REQUEST FOR NRC CONCURRENCE ON REA FOR 931 NORTH FIRST STREET IN GRAND
JUNCTION, COLORADO (GJ-00447-CS)

REQUEST FOR NRC CONCURRENCE ON REA FOR GRAND JUNCTION VICINITY PROPERTY

RE: Location Number 00447
931 N. 1st St., Grand Junction CO 81501

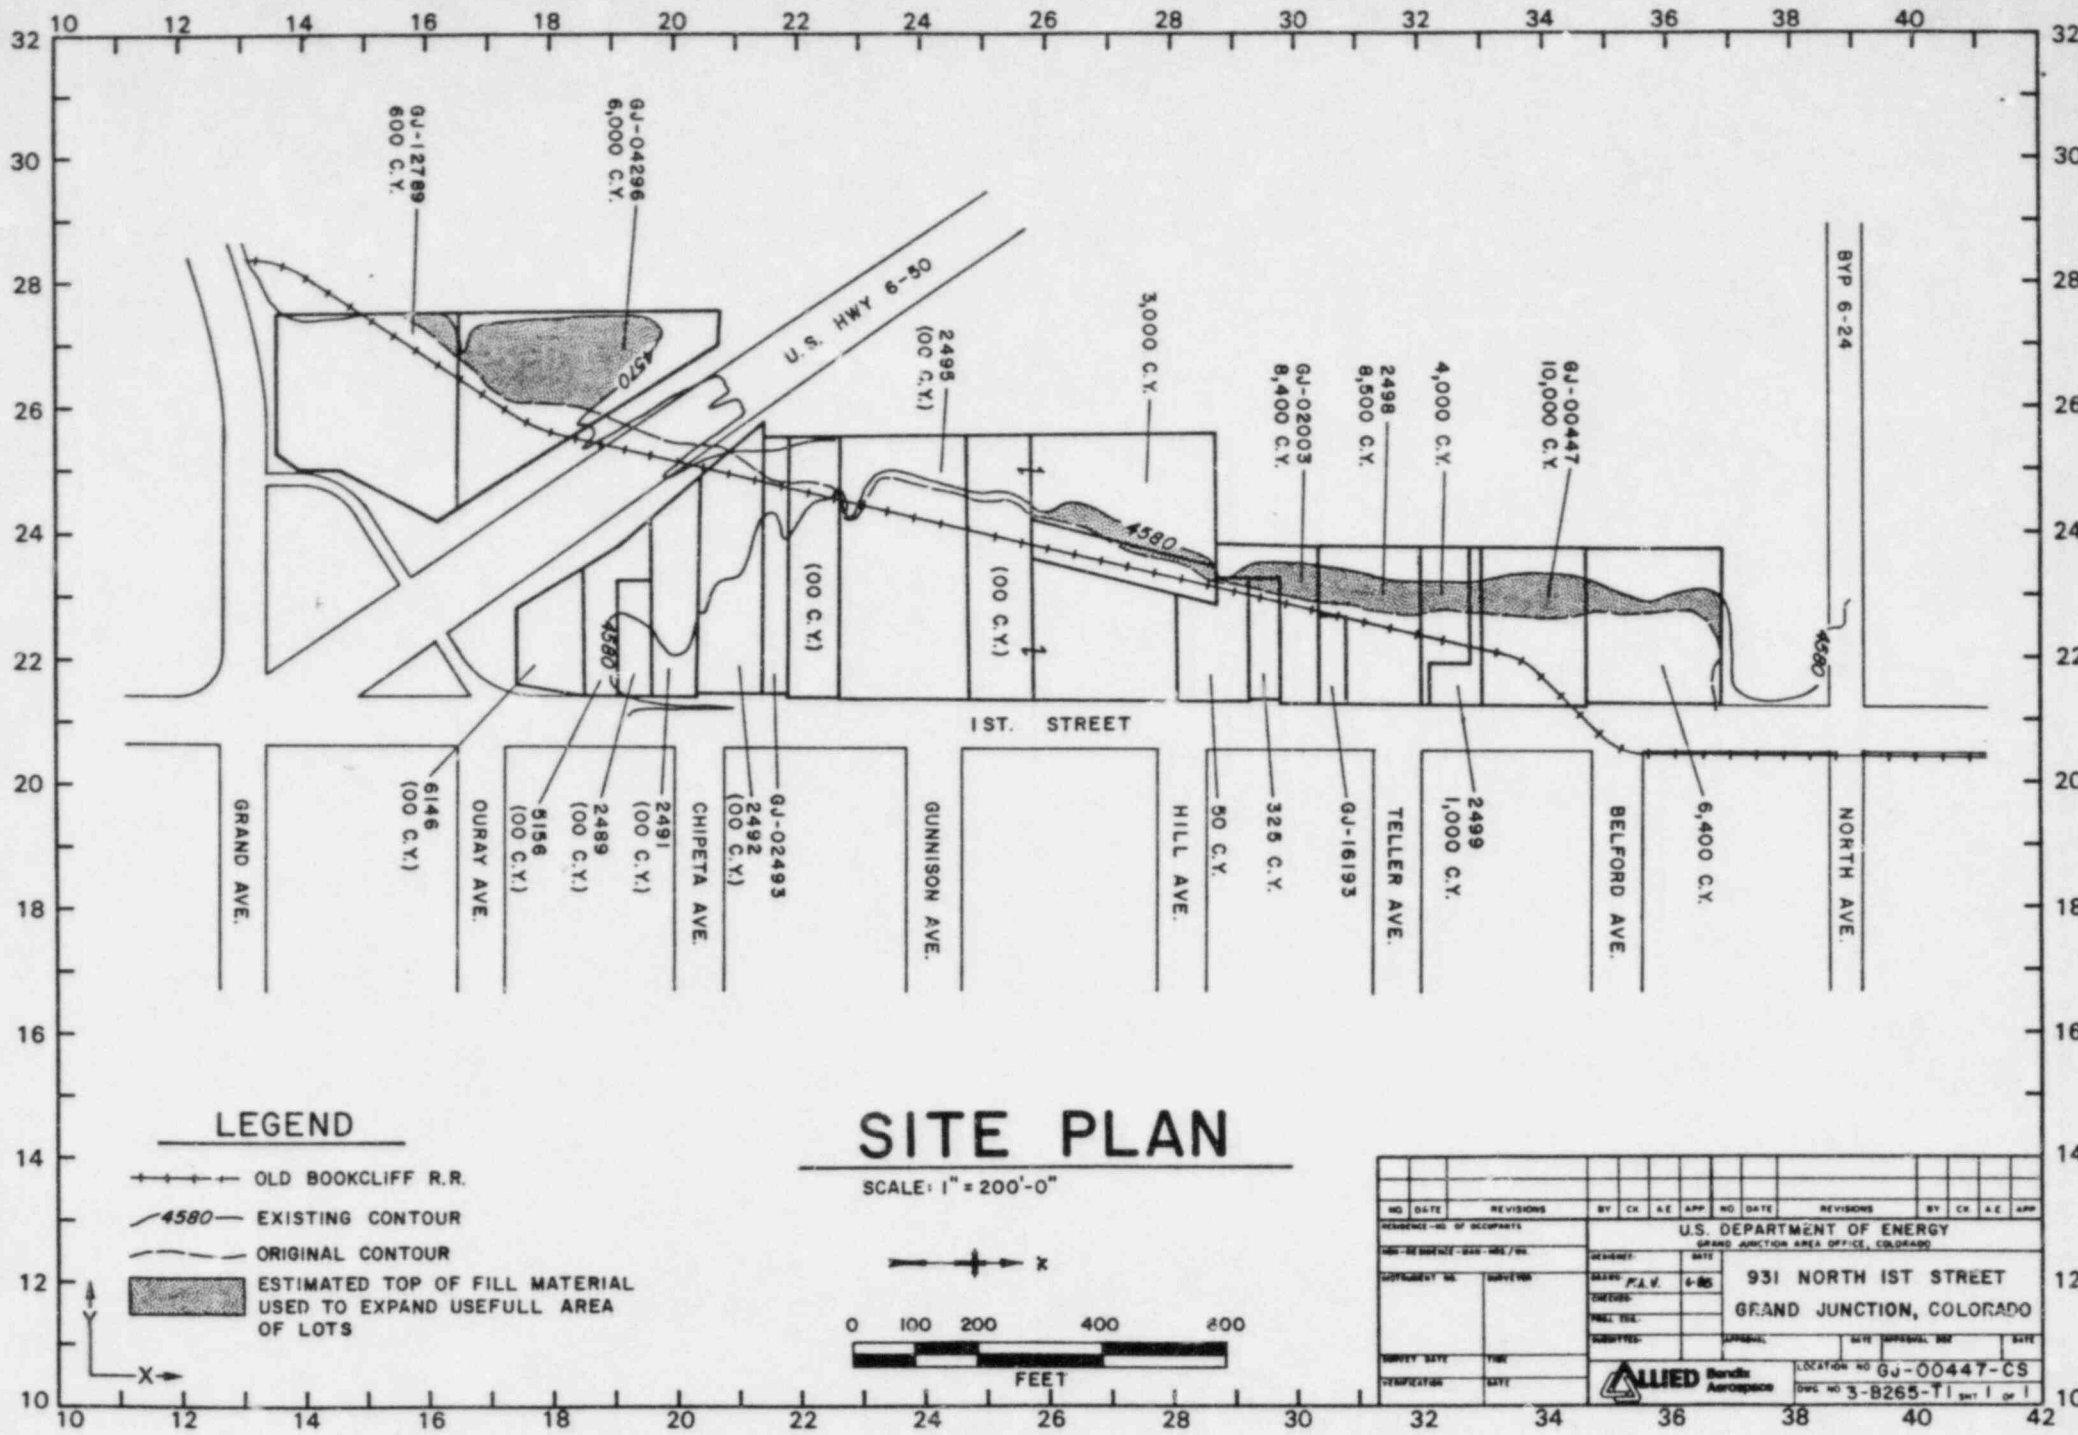
The embankment runs for a distance of one-half mile along First Street (from Grand Avenue to North Avenue), and there are at least ten additional locations where construction rubble mixed with uranium mill tailings is suspected of being utilized as fill material. It is estimated that the total volume which may be required to be removed is in excess of 48,000 cubic yards, and may cost as much as \$2.4 M to remove and replace the material. A site plan is attached showing the property locations and estimated quantities of materials.
